Site: Sunset Villa Subdivision – K12E003_T

Re: Drainage Ordinance (14-5-2-1) Violations for Erosion and Sediment Control

Photos are shown below.

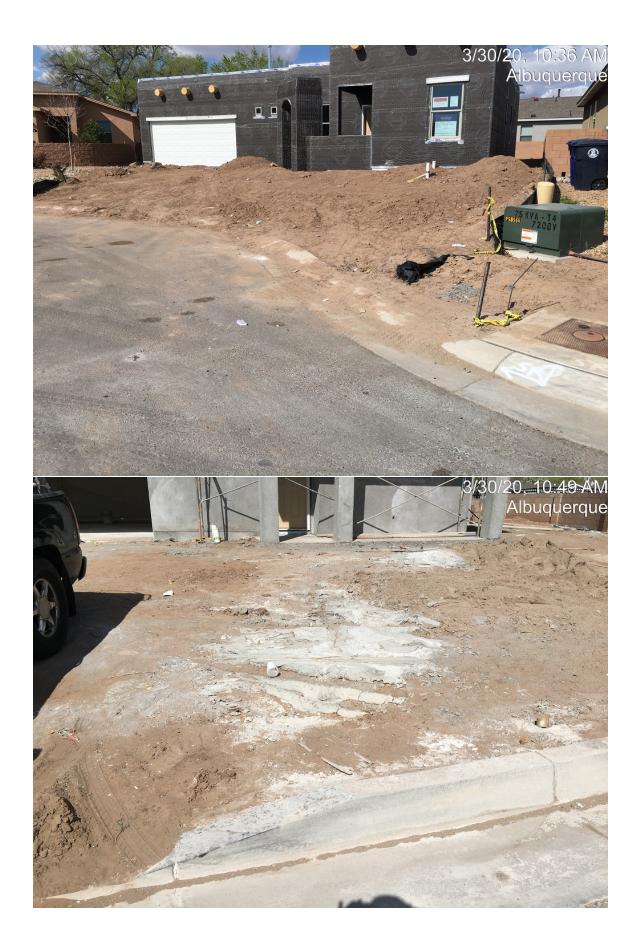
- 1. Stormwater controls (BMPs) are missing and in need of repair, specifically in the front yards of the new houses under construction. The grade behind the curb is higher than the street allowing sediment to easily enter the street.
- 2. Sediment associated with new house construction is in the adjacent street.
- 3. The site is littered with washout in association with the new homes under construction.
- 4. Construction waste is not in acceptable container.

- 1. Install and maintain perimeter BMP's, such as cut-back (see attached detail). Prevent sediment and other pollutants from entering the adjacent streets.
- 2. Where sediment from the lots enters the adjacent streets remove the deposited sediment by the end of the same business day in which the it occurs
- 3. Direct wash water from stucco, paint and concrete into a leak-proof container or lined pit. Remove and properly dispose of existing washouts.
- 4. Dispose of construction and domestic waste in acceptable containers daily and use lids or tarps to cover waste containers when not in use.
